December 2019
INT FL834
NHTSA #19V-722
Transport Canada #19-508
INTERIM RECALL

Subject: Western Star Baggage and Sleeper Doors

Models Affected: Specific Model Years 2017-2020 Western Star 4900 and 5700 vehicles manufactured November 14, 2016, through September 12, 2019, and equipped with certain baggage and sleeper doors.

Fig. 1, Door Flange Trim Location

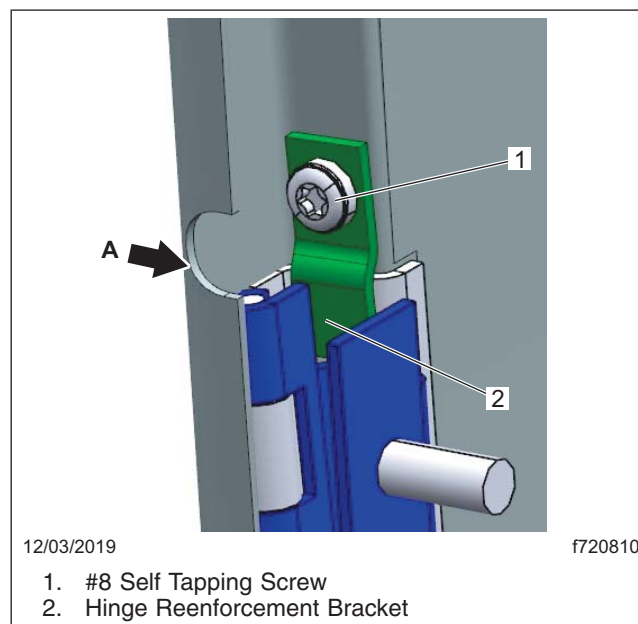
1. Park the vehicle on a flat surface, set the parking brake, shut down the engine. Chock the Tires.
2. Open and remove the baggage or sleeper door.
 - For sleeper door removal instructions refer to **Section 72.02, Subject 100** in the *Western Star Workshop Manual*.
 - For baggage door removal instructions refer to **Section 72.01, Subject 110** in the *Western Star Workshop Manual*.
3. Using tape, mask off the portions of the door flange and hinge that will be marked and trimmed.
4. Mark out the areas of the door flange to be trimmed. This is to allow tool access for a #8 self tapping screw. See **Fig. 1**, ref. **A**.

Fig. 3, Door Hinge Trim Location

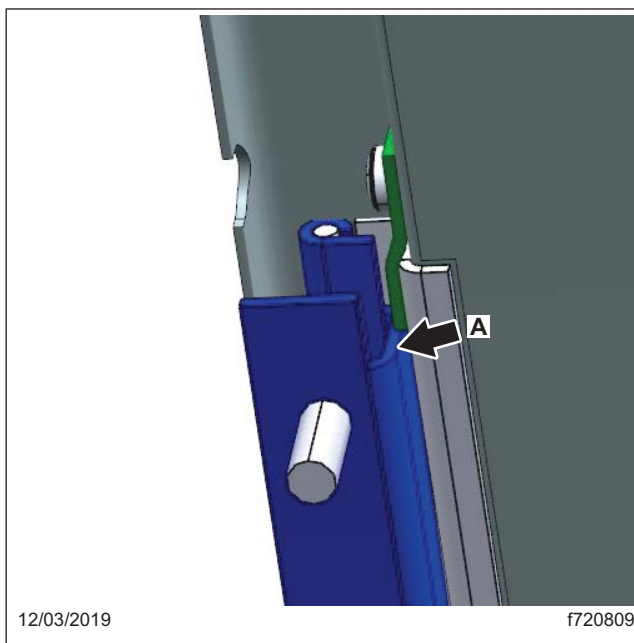
6. Mark out the areas of the door hinge that will need to be trimmed to allow clearance for the new bracket. See [Fig. 3](#), ref. **A**.
7. Trim the door hinge as shown in [Fig. 3](#). Trimming past the bend in the hinge to allow full range of motion.

Fig. 4, Hinge Reinforcement Assembly

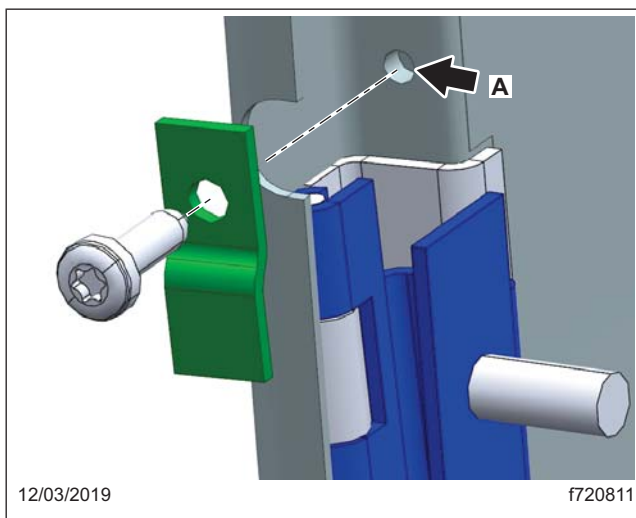
8. Install the new brackets to the top and bottom of the hinge using #8 self tapping screws and tighten the screws to 10 lb-in (113 N-cm) and not to exceed 2500 rpm. See [Fig. 4](#) and [Fig. 5](#)
